**LOW IMPACT DEVELOPMENT (LID)  
DEVIATION FROM ENGINEERING DESIGN &  
DEVELOPMENT STANDARDS (EDDS) –  
PAVEMENT, PLANTER AND SIDEWALK WIDTH  
FOR DEVELOPMENT OF 194<sup>TH</sup> ST SE**

**Project Name:** Clearwater Commons

PFN: 06 131051 000 00 LU Clearwater Commons  
Received - 12/12/2006

**FIGURE 1.  
CLEARWATER COMMONS  
SITE PLAN SHOWING LID  
MEASURES** NTS

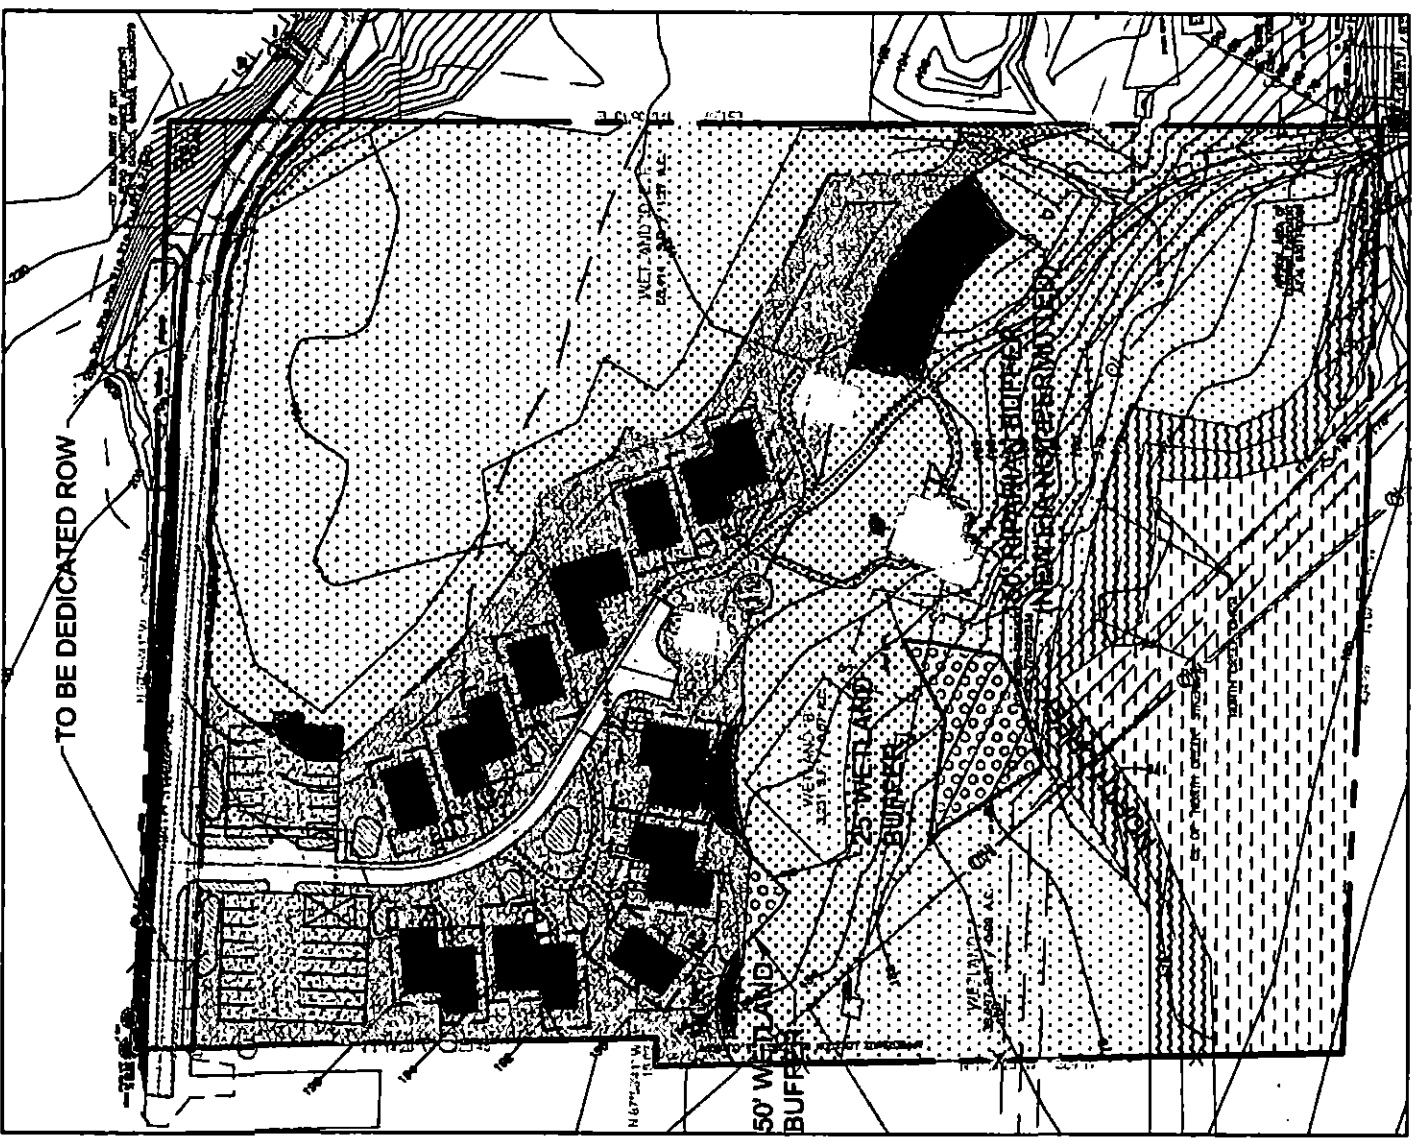
The site plan shown in Figure 1 shows the areas where composted-amended soils will be added to the site soils and rototilled to a depth of 1 ft. This area comprises 1.18 acres or 53% of the site, out of a total of 2.19 acres of developable area within the site.

**Figure 3. Compost Amended Soil Section  
CLEARWATER COMMONS**

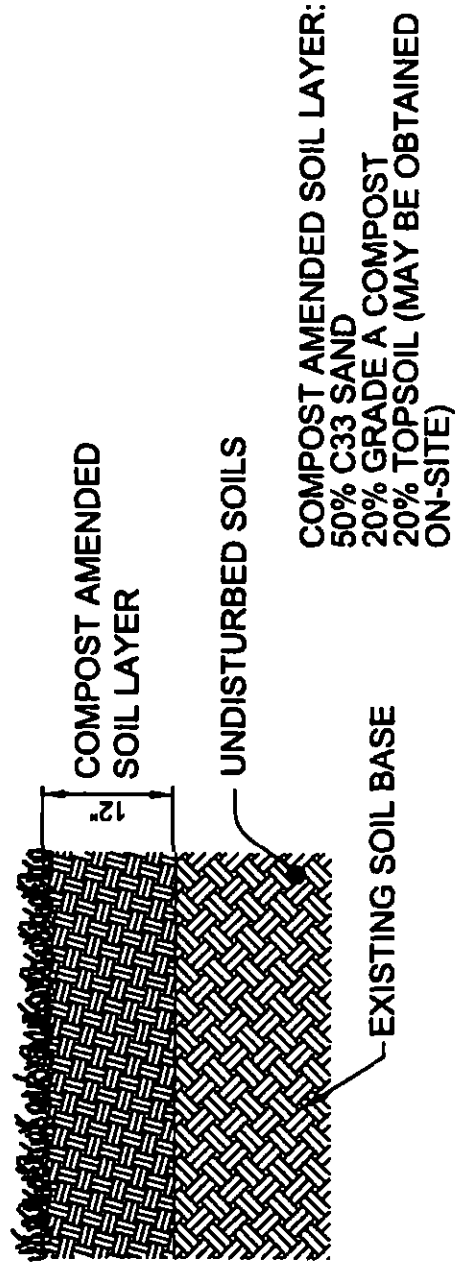
A detail of the compost-amended soil layer is shown in Figure 3. The result of the WWHM2 modeling showing 100% infiltration is provided in Figure 4.
